Staff Report to the Ogden Valley Planning Commission

Application Request: Consideration and action on preliminary approval of Gateway Estates Subdivision Phases 2-22, consisting of 21 lots, and public and private road dedication.

File Number: UVG052523

Exhibit B- Subdivision Plat

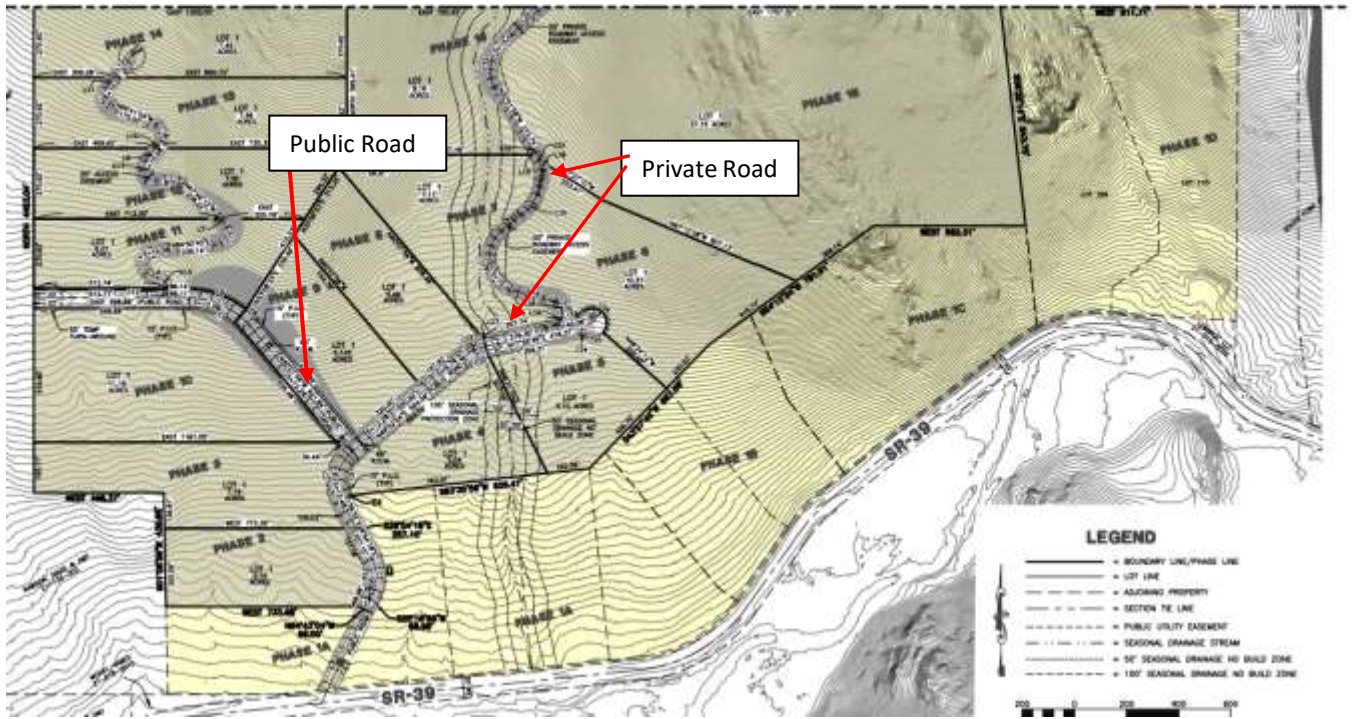
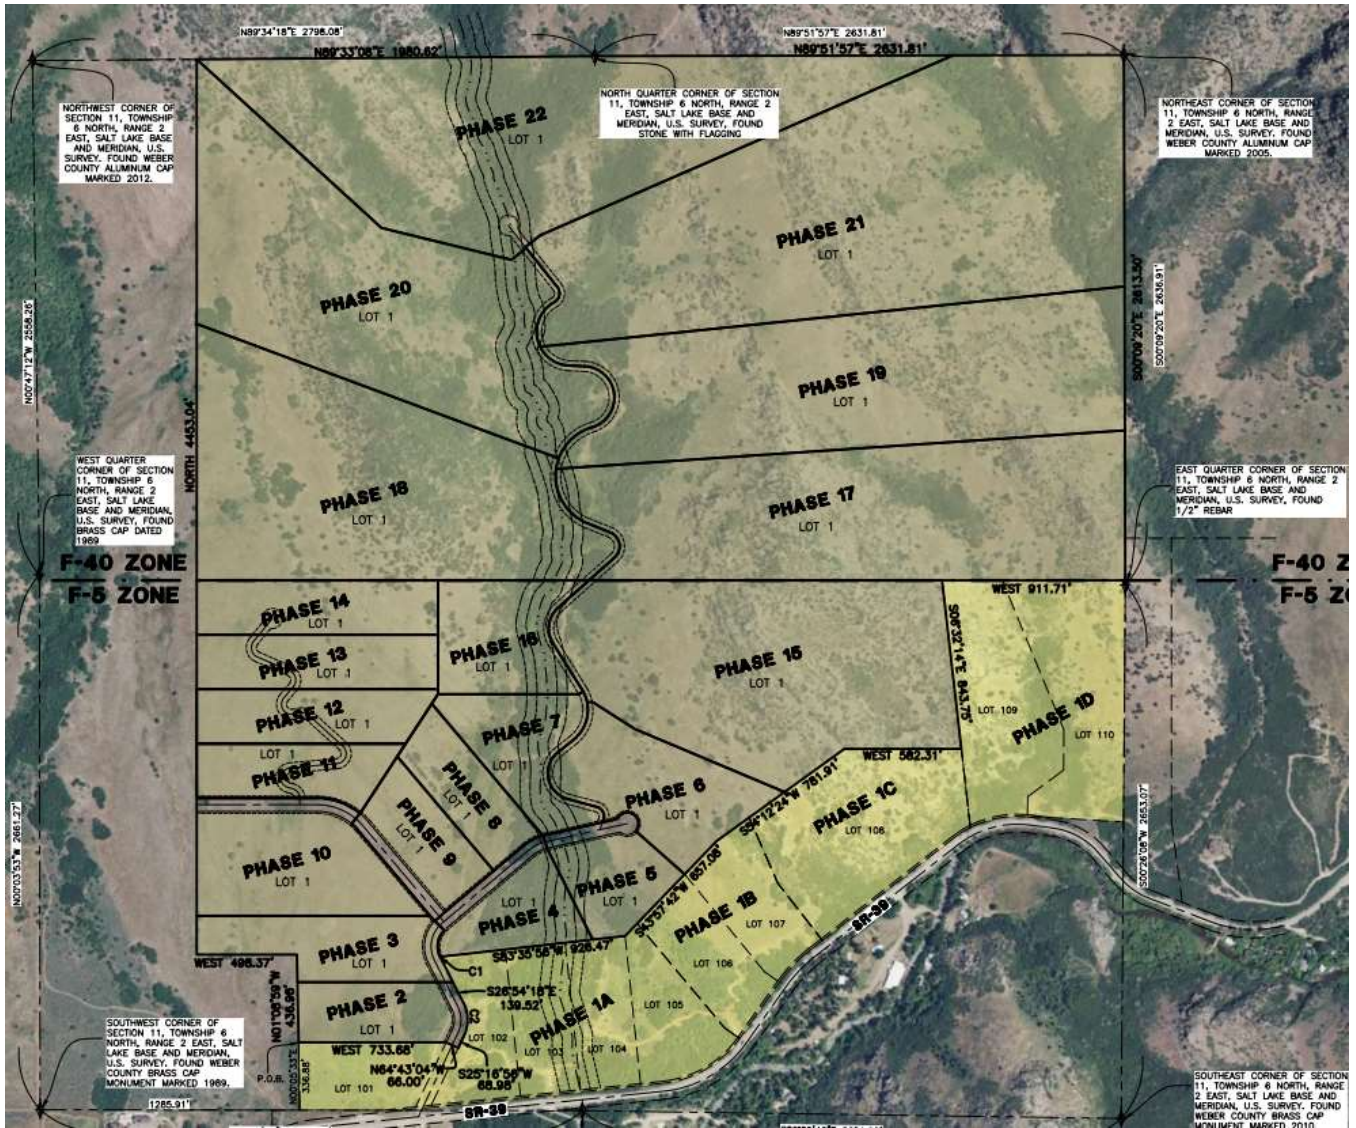
Lot area, frontage/width and yard regulations: In the LUC § 104-9-4, the F-5 zone requires a minimum lot area of 5 acres for a single family dwelling and a minimum lot width of 300 feet. The width and area of all 15 phases in the F-5 zone this proposed subdivision meet this requirement. The width and area of the 6 phases in the F-40 zone also meet the minimum area of 40 acres and width of 660 feet. Dedication of a new public road, located along phases 2, 3, 9, 10, and 11 and is included as part of this proposal. The private right-of-way begins along the frontage of Phase 4, and continues north up to Phase 22 (see Exhibit A) .

Street Standards: As the slopes and geology within these proposed subdivision phases are significant, Engineering and Planning are expecting that most of the roadway to the east, within this subdivision, will be privately owned and maintained.

In order to provide for future connectivity, the roadway coming north into the subdivision from Highway 39, and heading west, will be a public right-of-way.
